# City of Santa Clara

Stevens Creek Subaru

**RE: Violation of Approved Rezone and Use Permits (File No. PLN2015-11350 and PLN2016-11888)**

A1.0

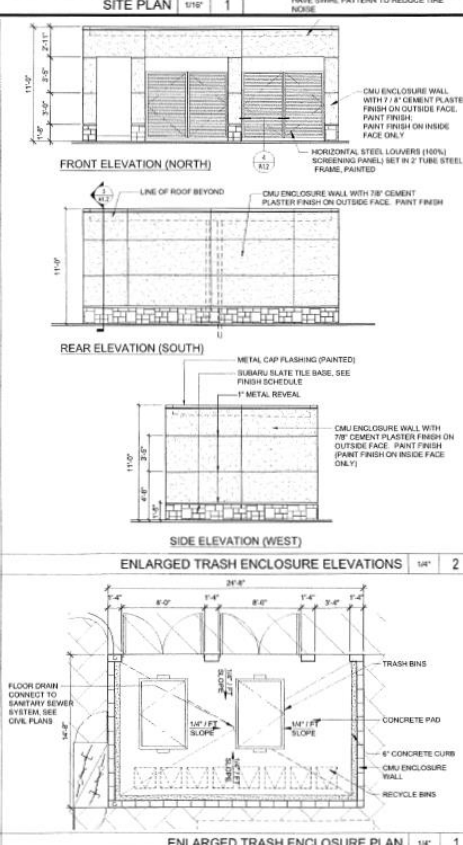
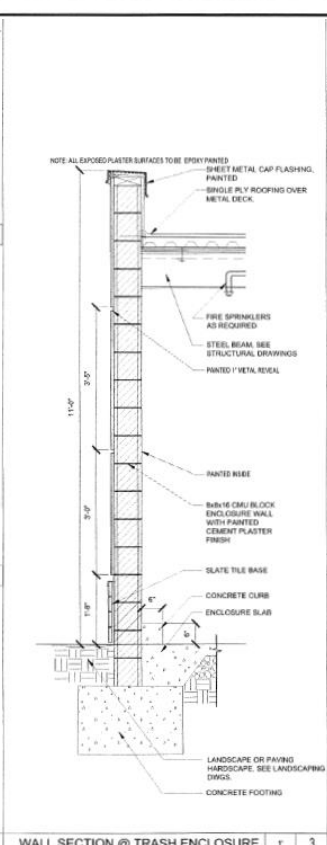
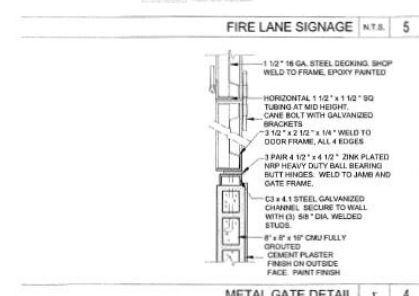
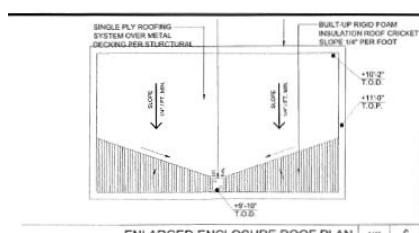
It has come to the City's attention that the required trash enclosure for the above approved and completed project was never constructed. Please be advised, that per the conditions of approval (P3 and ST1) below and in the attached Conditions of Approval, a trash enclosure is required for the project. Any modification to the trash enclosure location requires an amendment to the Use Permit.

Recent communication with the City of Santa Clara Public Works Department and Mission Trail Waste Systems, have indicated that the location of your trash enclosure as shown on your permit plans does not meet Mission Trail requirements for trash pickup. Currently, solid waste from 3225 Stevens Creek Boulevard is relocated to 3155 Stevens Creek Boulevard for service. However, each entity must subscribe to and maintain solid waste services independently. This requires you to submit a new solid waste collection plan for review.

To allow for solid waste services and resolve this violation the following must occur:

1. Application for a Minor Amendment to an Approved Permit, to address the lack of constructed trash enclosure,
2. Submittal of a formal written request on company letterhead requesting a red curb be installed on Stevens Creek Boulevard to allow Solid Waste collection and/or
3. Application of a Use Permit Amendment if condition modification is necessary (to allow service on Cecil Avenue)
